Attachment 1. Staff Assessment of Precinct A (CURA-A) Proponents' proposal for amendment of draft s.94 plan.

9.1 Cumbalum Precinct A - Contributions Plan and DCP Provisions.DOC

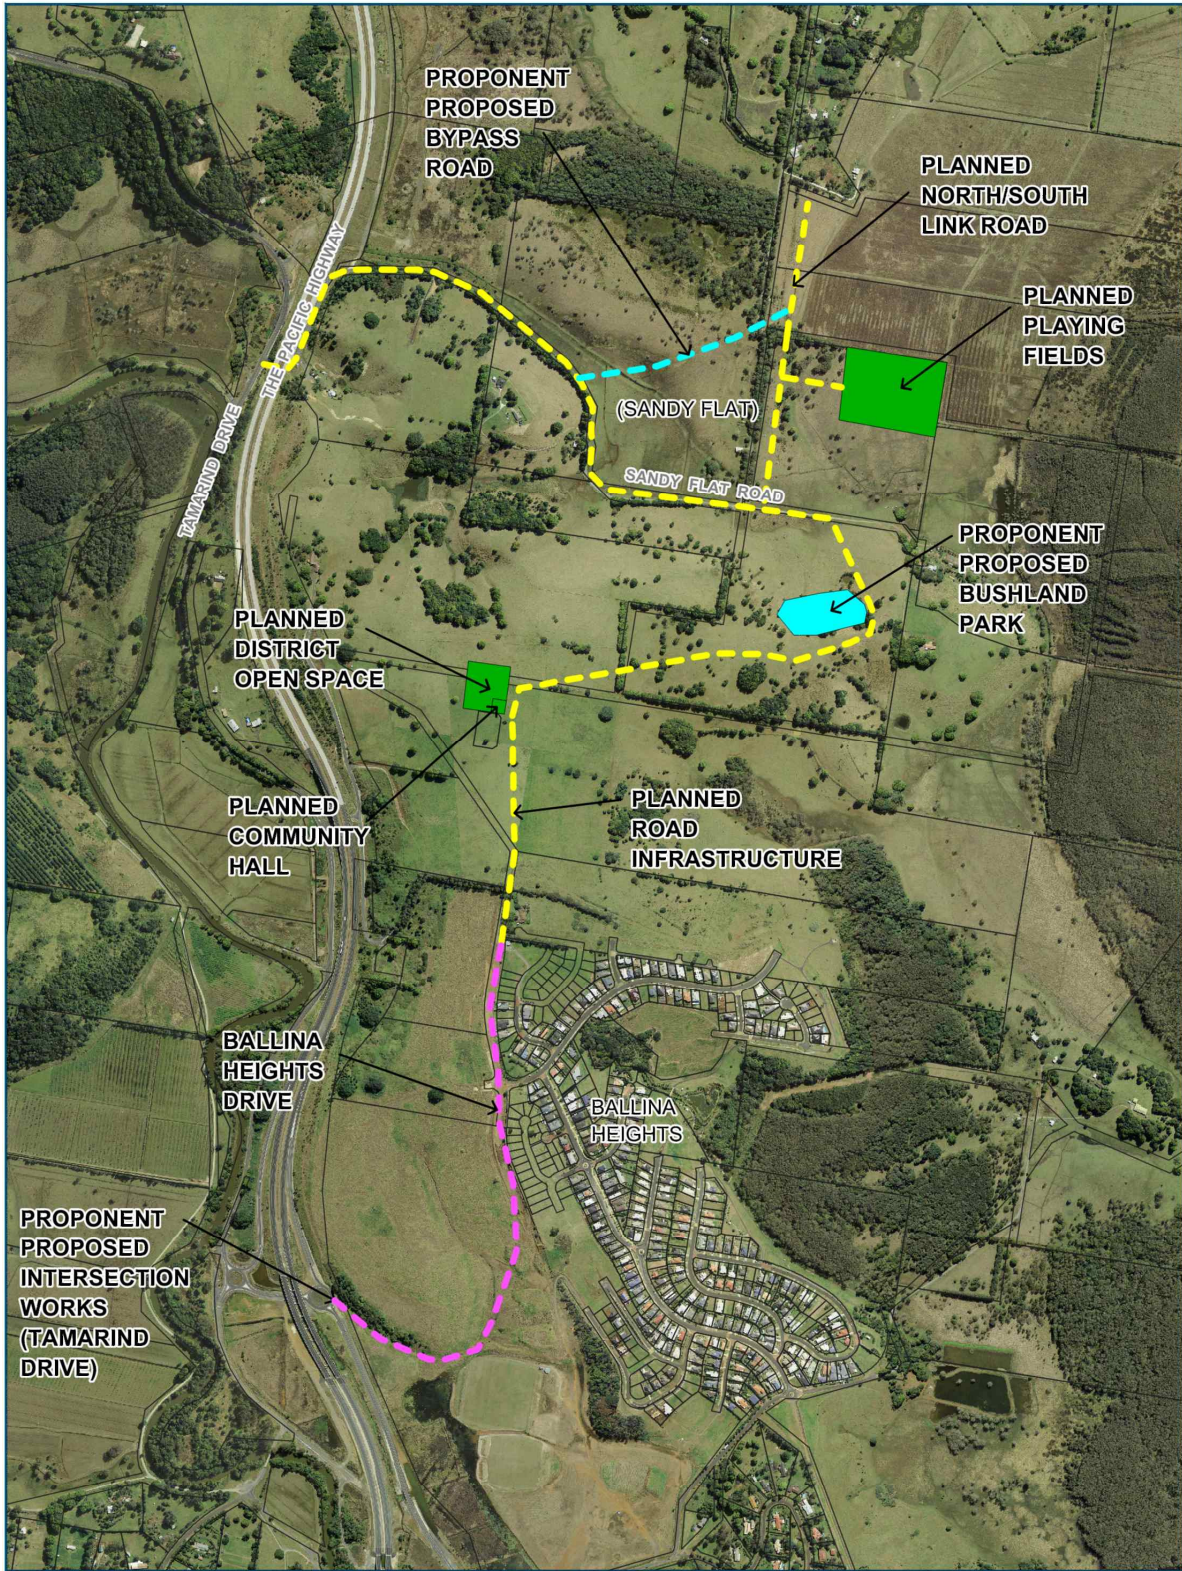
Proposal	Staff Assessment
<p>The dedication of land for works delivered through s.94 plan separate to the s.94 plan.</p>	<p>Under this proposal, early stages of the development would not be called upon to dedicate land, whereas latter stages of the development could be expected to dedicate more land than the demand generated by that stage of the development. This could potentially undermine the delivery of the infrastructure to be provided by the development as a whole, if latter stage landholders argue that such dedication would be unreasonable.</p> <p>To be properly secured, such an arrangement would need to be made legally binding, such as through a voluntary planning agreement.</p>
<p>Removal of the planned direct north-south link road with Precinct B.</p>	<p>The provision of a convenient and reasonably direct linkage between the two (future) substantial new villages is considered to be strongly in the public interest. It is noted that a direct north-south link road is expected to benefit the future residents of both Precinct A and Precinct B.</p> <p>With respect to discouraging through traffic from Precinct B through Precinct A, it is noted that, due to a higher speed environment, south bound travel times via Sandy Flat Road and Tamarind Drive, may be less than travelling through CURA-A.</p> <p>Notwithstanding, a number of measures may be implemented to mitigate the potential for unnecessary through traffic, such as careful road design and the implementation of traffic calming measures. Accordingly, provisions to this effect have been incorporated into the draft development control plan for CURA-A.</p>

<p>The inclusion of a Precinct B bypass road.</p>	<p>Beyond a promise to dedicate land, the developers do not identify a funding mechanism for the delivery of the bypass road. The estimated cost of construction is \$10.5 million. Further comments as per above, relating to the provision of the north-south link road.</p>
<p>The inclusion of the extension of Ballina Heights Drive to Sandy Flat Road in s.94 plan.</p>	<p>It has been previously noted, that the future upgrade of Sandy Flat Road could reasonably be made a condition of development consent in association with the future development of CURA-A. Notwithstanding, Council acknowledges the potential difficulties associated with the delivery of this road upgrade, due the staging of the</p>

<p>development and mixed land ownership.</p> <p>It is noted, however, that including the projected cost of the upgrade into the CURA-A s.94 plan (approximately \$3M works) would exceed the capacity of the Precinct A s.94 plan due to the State Government cap on development contributions (leaving \$1.5M unfunded).</p> <p>Staff recommend the consideration of including the upgrade of Sandy Flat Road into the shire-wide s.94 roads plan, a review of which is currently underway.</p>
<p>The inclusion of intersection upgrade works to Tamarind Drive roundabout in the s.94 plan, for the purposes of improving intersection safety.</p>	<p>The developers have proposed the inclusion of works to the Tamarind Drive intersection with Ballina Heights Drive, into the CURA-A s.94 plan, for the purpose of improving the safety of the intersection.</p> <p>It is noted that s.94 of the EP&A Act 1979 allows the collection of contributions where it can be reasonably anticipated that the development will give rise to additional demands on public infrastructure or amenities. It is questionable as to the extent to which section 94 contributions can be used to rectify safety or design issues that potentially already exist. It is possible though to levy contributions (in full or on a proportional basis) where infrastructure capacity needs to be augmented, to accommodate additional demand created by development.</p> <p>It is further noted that should the intersection require upgrading as a consequence of the additional demand created by the future development of Ballina Heights and/or CURA-A, then these works could reasonably be made a condition of development consent.</p> <p>The identification of other priority infrastructure in the CURA-A s.94 and the imposition, by the State Government, of the cap on the maximum contribution amount that can be collected (\$30,000 per dwelling) means there is insufficient capacity to include additional items in the CURA-A s.94 plan.</p>

<p>The inclusion of a 'Bushland Park' as a component of the planned district park infrastructure.</p>	<p>The proposed bushland park, although large in area (16,500m²), does not comprise usable open space. In this regard, it is noted that 42% of the proposed park has a slope of over 30 per cent, 54% has a slope between 20 and 30 per cent slope and only 4% of the proposed park area has a slope of less than 20 per cent. Further, the site is heavily vegetated with protected native vegetation.</p> <p>Council's Manager of Open Spaces recommends the consolidation and centralisation of district open space facilities in order to optimise usability, embellishment</p>

and maintenance. Consequently, the bushland park is not considered suitable to meet district open space requirements associated with the development.
Reduced extent of site preparation works to the district park/s.	<p>The proponents sought to reduce the amount of site preparation works, to the district park, as follows:</p> <ul style="list-style-type: none"> • Reduced 'site clearing' from 10,000m² to 500m² • Reduced area of 'turf' from 9,000m² to 3,000m². <p>No justification for reduce site works have been provided. Site preparation works, commensurate with the area of the site, will be needed to embellish the district park to the required standard. In the absence of details supporting reduced rates, it is recommended that the original estimates be retained.</p>
Reduced assumed population yield.	<p>The developers' proposal involved an amendment to the projected dwelling yield from 738 to 820 dwellings. Consequently, it is proposed that a development yield of 820 dwellings be assumed, for the purpose of the s.94 plan.</p> <p>The developers' proposal also involved the amendment of assumptions relating to the average number of persons per dwelling (from 2.7 to 2.4), with the implication that fewer facilities would be required for the same number of dwellings.</p> <p>It is noted that the average number of persons per dwelling in Ballina Heights/CURA-A was 3.1 persons per dwelling in 2011. Consequently, the rate chosen by Council for the s.94 plan, already provides some discount, recognising that the occupancy rate will likely decline as the locality ages. Notwithstanding, 2.7 persons per dwelling is a typical occupancy rate for new release areas. Therefore the current occupancy rate, used in the draft s.94 plan, is considered reasonable.</p>
